An Urban Design Report ('UDR') was approved as part of the original B3 Reserved Matters submission. That document demonstrated the underlying approach to the design of Building B3 and how the relevant Design Guidelines attached to the Outline Planning Permission have been observed.

The following paragraphs set out the proposed changes and design rationale in more detail, as an addendum to the approved UDR.

# King's Cross

Figure 2 (above): Extracts from drawings showing handrail arrangements on steps between B1 and B3 as approved (above) and proposed (middle). Below, a CGI shows the revised handrail arrangements on steps between B1 and B3.

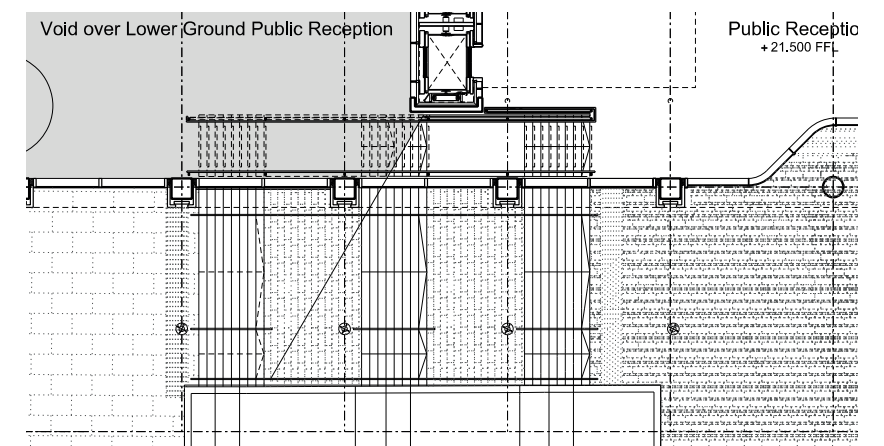
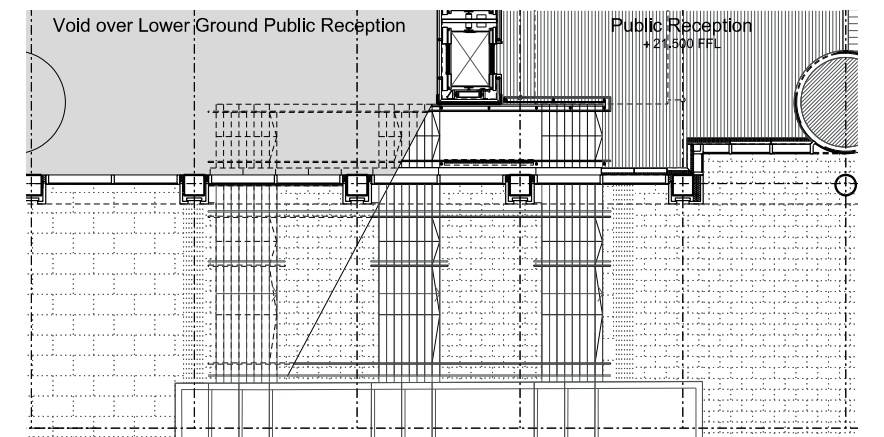
Under the approved scheme, steps were located alongside the southern facade of the building, in the secondary street between Buildings B1 and B3. This responded to the 4.5 metre difference between the lower ground and upper ground floor levels of the building, and of the adjacent public realm. The external staircase continued through the facade and into the reception area, giving the impression of being one wide staircase, albeit divided by a glass partition.

As part of these minor amendments, the stair treads have been increased from 280 mm to 300 mm to improve access and safety to members of the public. Further, the two sets of handrails running down the external flight of stairs have been moved away from the Building B3. The proposed distance between the central and the external handrails are as previously approved, albeit flipped to provide a wider section of steps immediately adjacent to B3, as illustrated in Figure 2 to the right. The proposed change is considered to enhance the appearance of the facade while maintaining the accessibility of the steps in line with Part M of the Building Regulations.

Figure 4: Extract of drawings illustrating approved (top) and proposed (bottom) layouts of B3 entrances at lower and upper ground floor levels.

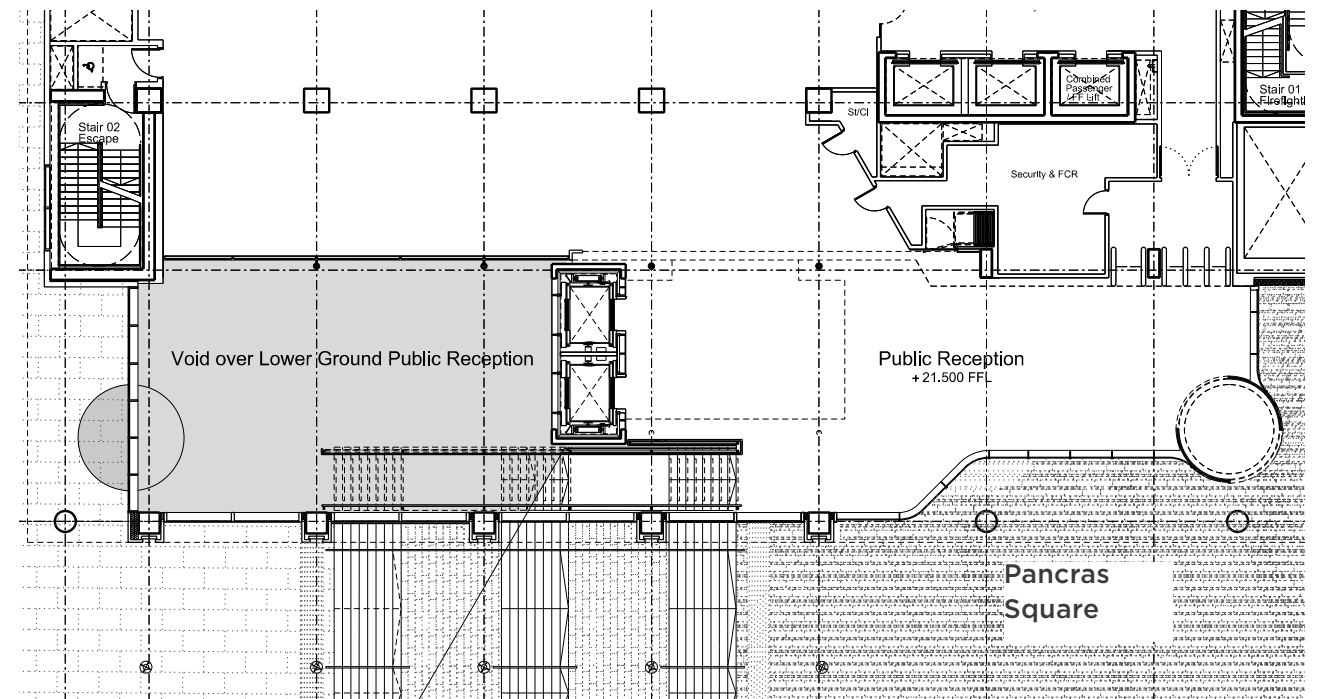
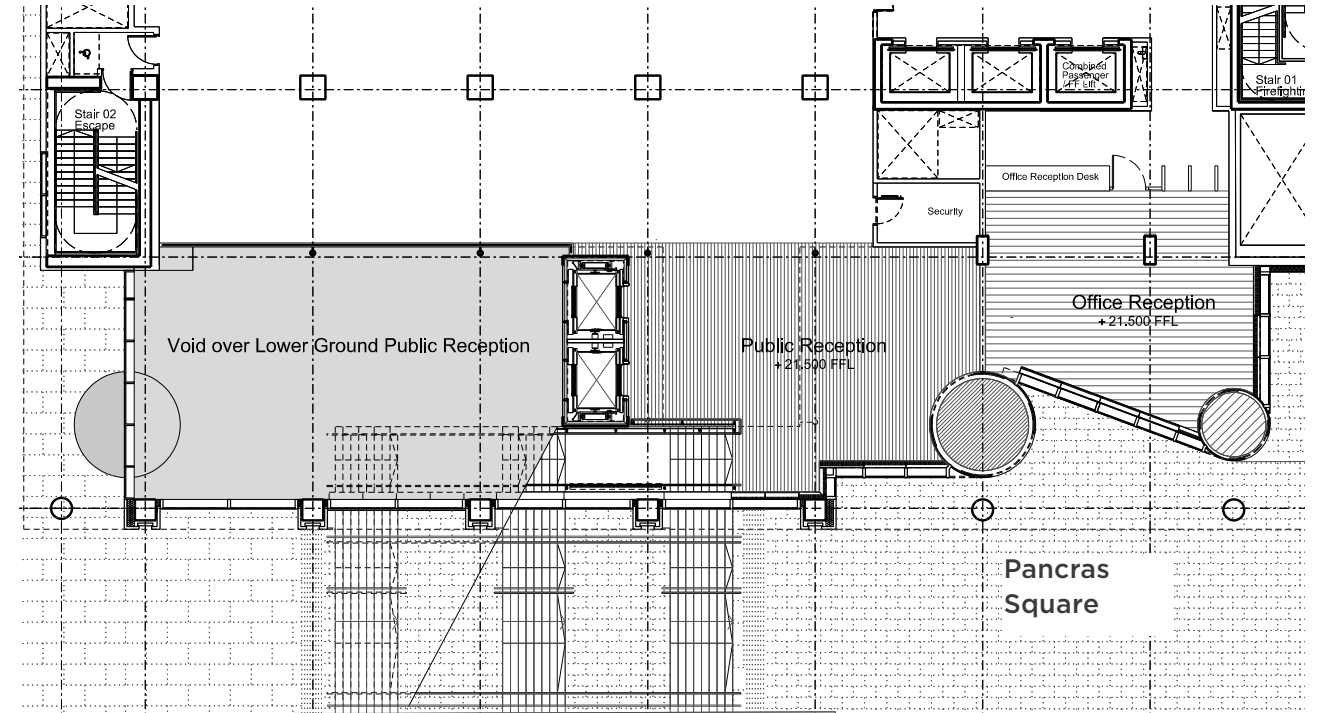
At upper ground floor, the proposed internal layout has been modified to combine a reception area that welcomes all visitors and staff, channelling users to the security turnstiles for the offices at the upper floor levels, directly to the Camden Customer Services Centre (previously referred to as the Access Centre) and Library at that same level, or to the public leisure centre at lower ground level, via the central staircase or lifts. The generosity of the space remains unchanged, with the double and triple height space stretching alongside the southern façade and providing an open visual connection between the public and office uses, as well as a route through the building, during opening hours.

Reflecting the shared nature of the reception area at upper ground level, one of the entrance drums at this level has been removed. As a result, the remaining entrance drum has been increased in size and its position shifted slightly on the corner of the building (See Figures 3 & 4). The southern glazed facade line has also been adjusted, resulting in additional covered space to shelter. Overall, the change to the entrance is considered to be an improvement to the approved scheme, creating a more democratic space and increased prominence in views across Pancras Square.

Figure 6: Approved (left) and proposed (right) B3/B5 'finger'.

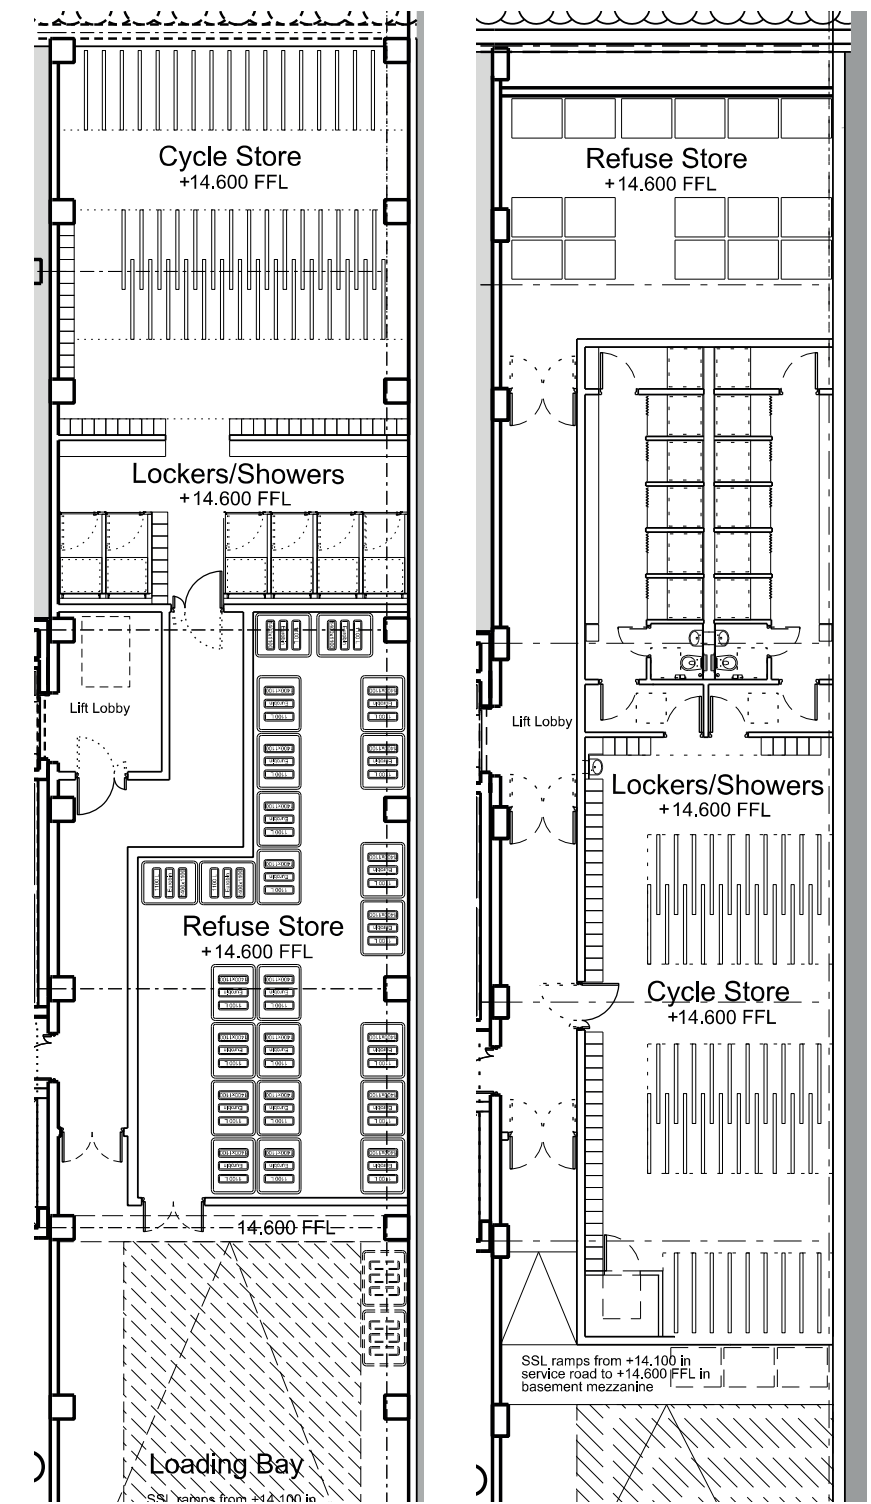
The basement service area within the B5/B3 'finger' has been enlarged by approximately 4m into the loading bay to accommodate additional cycle and shower facilities for staff and to incorporate a plenum between both buildings, to meet drainage needs for Building B5 (See Figure 7 to the right). However, operations within the new loading bay area will be unaffected by this change.

The revised layout of this area enables the provision of 12 showers, representing an increase of 6 on the approved scheme, and has enabled the shower room to be separated into male and female sections, which was previously not possible. Further, new facilities have been accommodated by reducing the size of the refuse storage area. These include 2 toilets, 2 vanity areas and a drying room for cyclists.

Figure 8 (above): Extracts from drawings showing approved (top) and proposed (bottom) balcony depths and door arrangements.

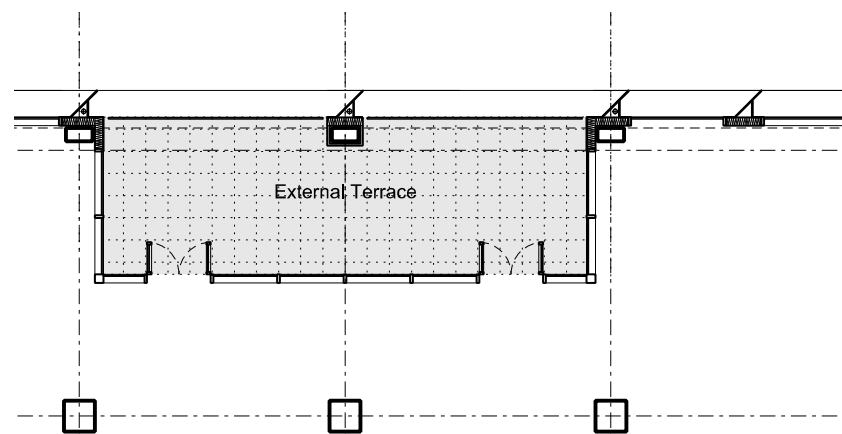
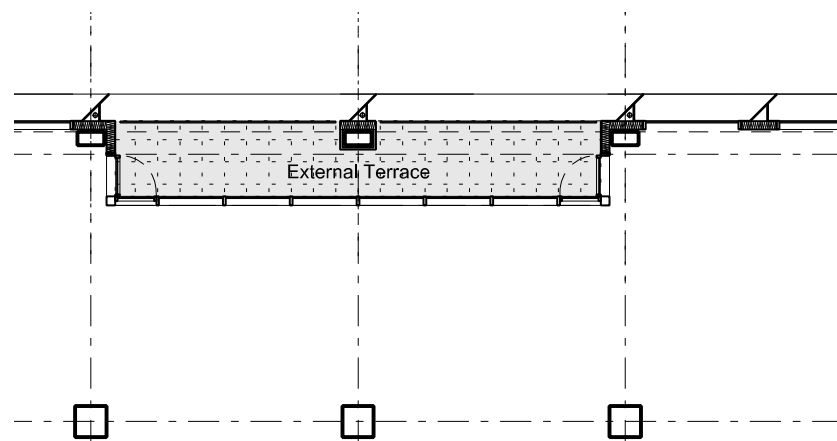
At levels 2 and 3, the proposed balconies and their voids have been reduced in depth from 1.35m to 0.65m on the northern facade, and from 2.1m to 1.1m on the western facade. At levels 6 and 7, the proposed balcony and void on the western facade have been increased in depth by 0.4m to make them parallel to internal walls.

Double doors to access the balconies on the north and west facades have been replaced with 1.1m wide single doors at either end of the balconies, opening outwards onto the external return walls to allow greater circulation space, as well as a more efficient desk layout within the building.
